WICHITA BOEING EMPLOYEES ASSOCIATION ADDITION

RE: SUB 2000-117 -- Final Plat of Wichita Boeing Employees Association Addition

At the regular meeting of the Subdivision Committee of the Metropolitan Area Planning Commission on Thursday, March 15, 2001, the above captioned plat was considered. The action of the Committee was to approve the final plat, subject to the following:

CASE NUMBER: SUB 2000-117-- WICHITA BOEING EMPLOYEES ASSOCIATION ADDITION

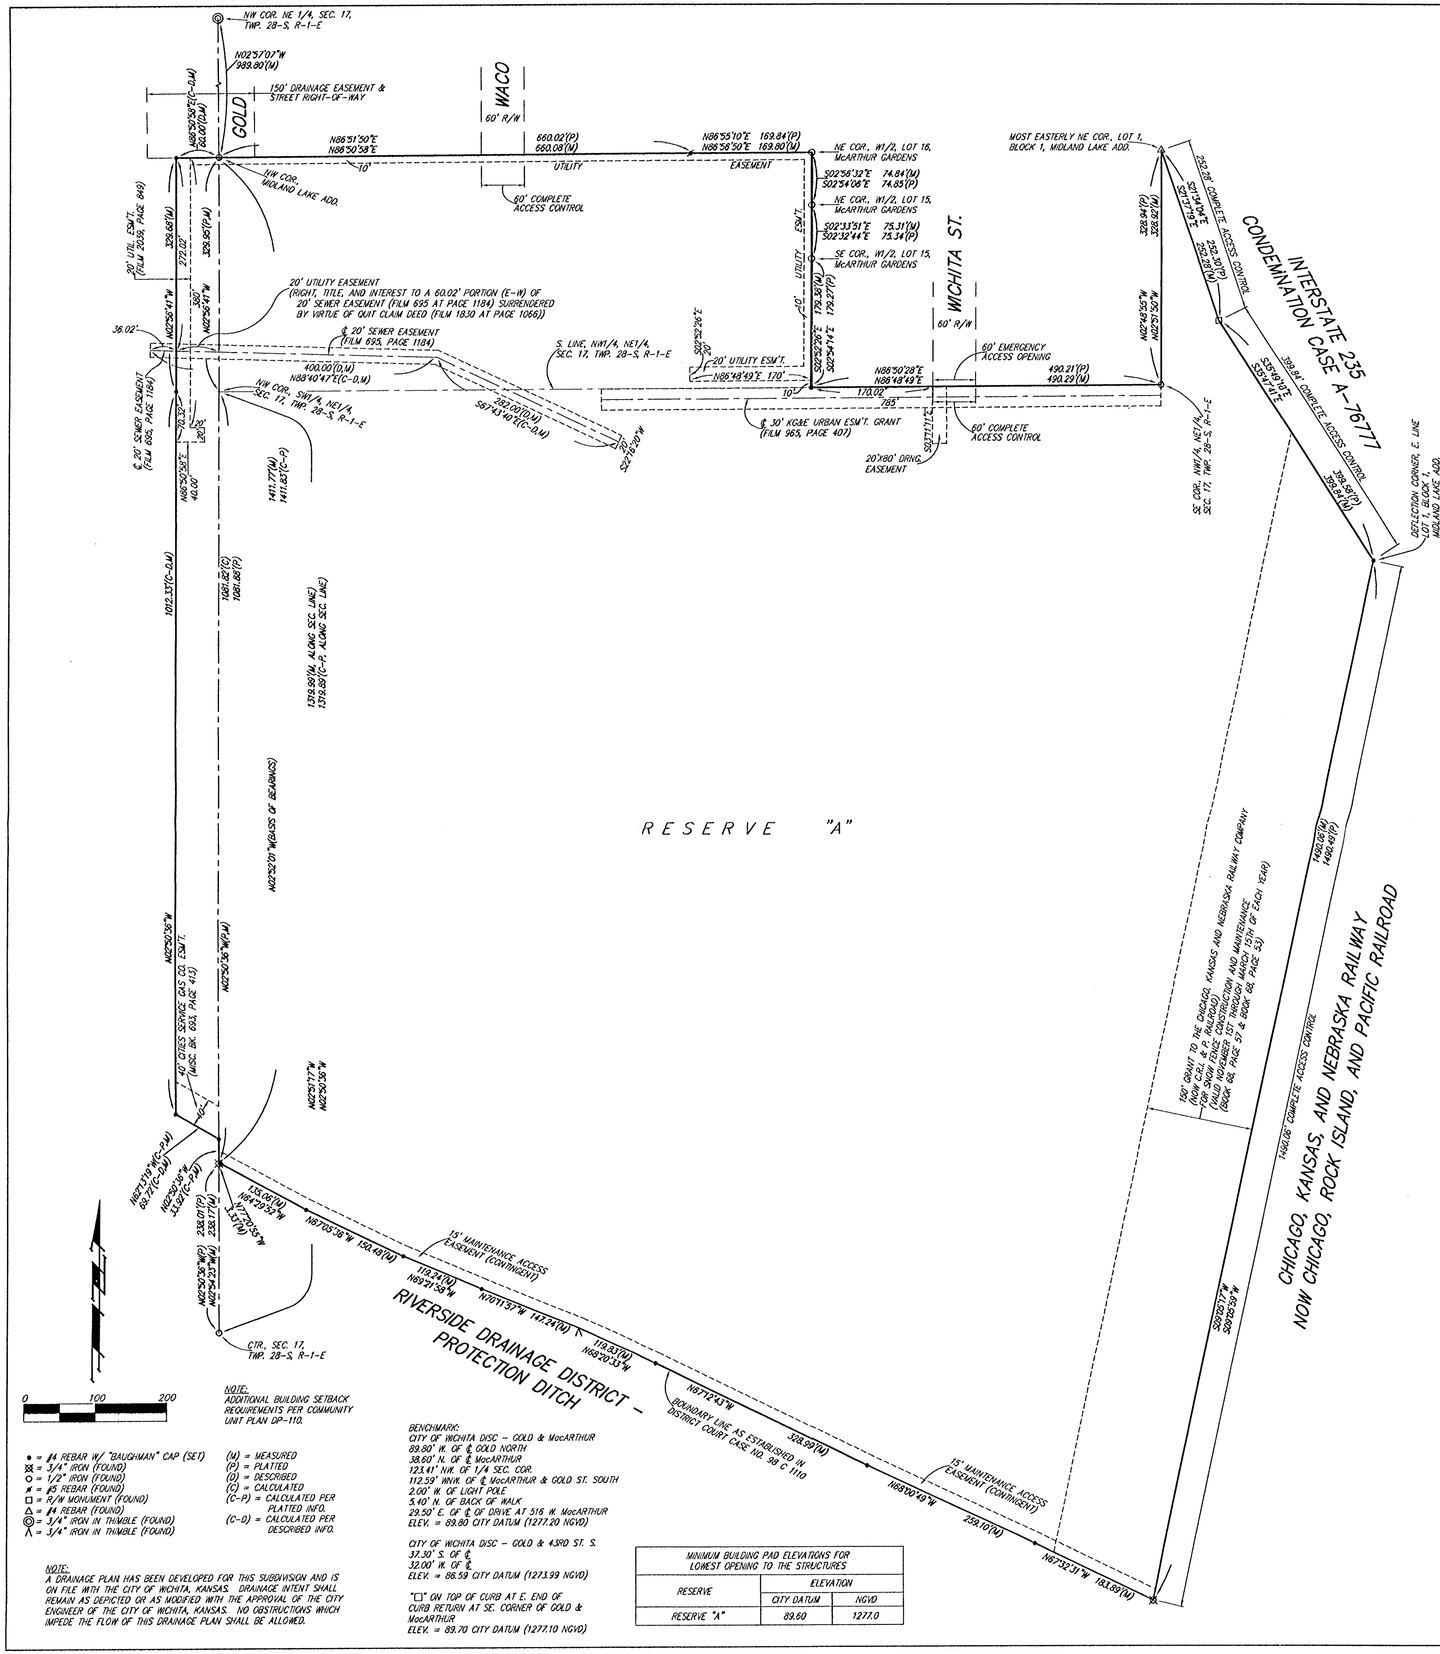
A. Municipal services are available to serve the site. City Engineering needs to comment on the need for any guarantees or easements. *A petition is required for the turnarounds at the terminus of Gold Street, Waco and Wichita.*

C. City Engineering needs to comment on the status of the applicant's drainage plan. *The drainage plan is approved.*

D. City Engineering needs to comment on the proposed vacation of the contingent maintenance access easement along the Riverside Drainage Ditch. *The applicant shall retain the easement on the plat.*

E. The primary access is through Gold Street. An emergency access is located at the south end of Wichita Street, and complete access control has been dedicated along Wichita and Waco. The final plat shall reference the access controls in the plattor's text as being dedicated to the appropriate governing body.

F. Mann Street, located adjacent to the north line of the plat, is not open and should be vacated. The applicant shall contact the property owners to the north to attempt to have this half-street right-of-way vacated. A portion of this street right-of-way will need to be retained as a hammerhead turnaround for Wichita Street.

J. The legal description needs to be revised by deleting "of the S ½ of the SW corner".

M. The plattor's text shall include language that a drainage plan has been developed for the plat and that all drainage easements, rights-of-way, or reserves shall remain at established grades or as modified with the approval of the applicable City or County Engineer, and unobstructed to allow for the conveyance of stormwater.
